DATE	01/15/96	CESSNA AIRCRAFT COMPANY
DRWN	ROBERT SCOTT	AIRCRAFT DIVISION
GROUP		P.O. BOX 7704
CHECK		WICHITA, KANSAS 67277
SECT		
PRD J		
M. E.		
OTHER		
FABRICATE PER	CES2606	SIZE
PROCESS PER	XXXXXX	DFW NO.
WIRE TERMINATION PER	CES2718	
SCALE: NONE		SHEET 1 OF 1

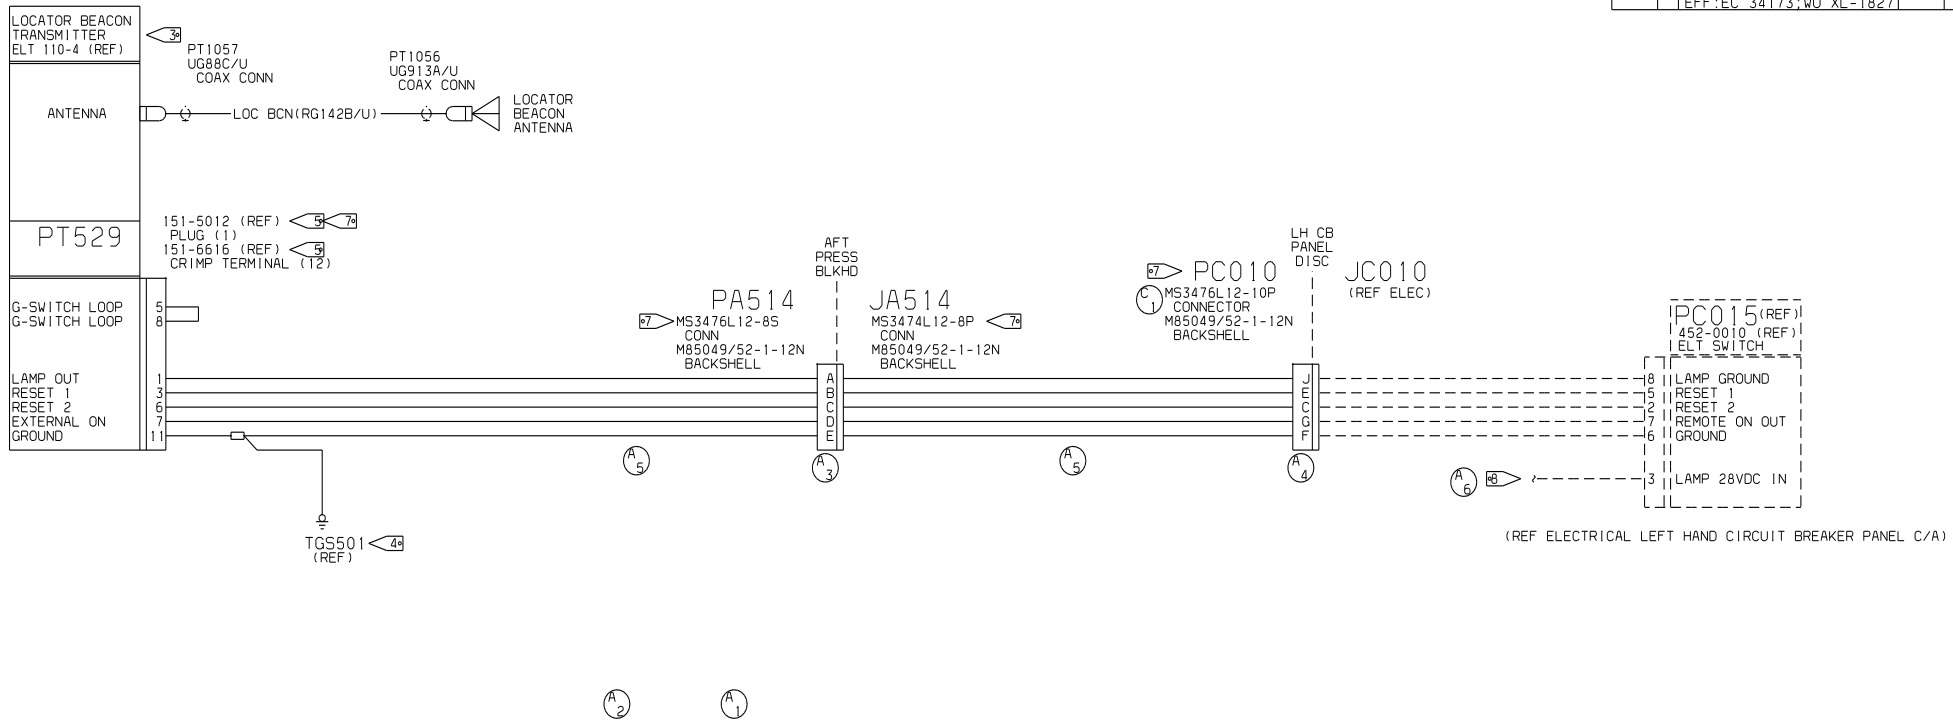
REVISIONS				
SHEET	REV	DESCRIPTION	DATE	APPROVED
A	BY REVISION:		03/14/96	
	1) DELETED JT/PT012		RBS	
B	2) DELETED AT506			
	3) DELETED PIN F OF PA/JA514			
	4) DELETED PIN D OF PC/JC010			
	5) DELETED THE FOLLOWING WIRES:			
	DPC010-FJA514			
	FPA514-AT506			
	AT506-WJ012			
6) CHANGED REF WIRE 3PC015-DJC010			03/29/96	
7) ADDED FLAGNOTE #8			RBS	
EFF: EC 34173; WO XL-0150				
C	BY REVISION:		10/11/97	
	1) CHANGED CONNECTOR AT PC010:		SEA	
	P/N WAS MS3476L12-105			
2) ID TAG P/N WAS CM2987-1				
EFF: EC 34173; WO XL-1827
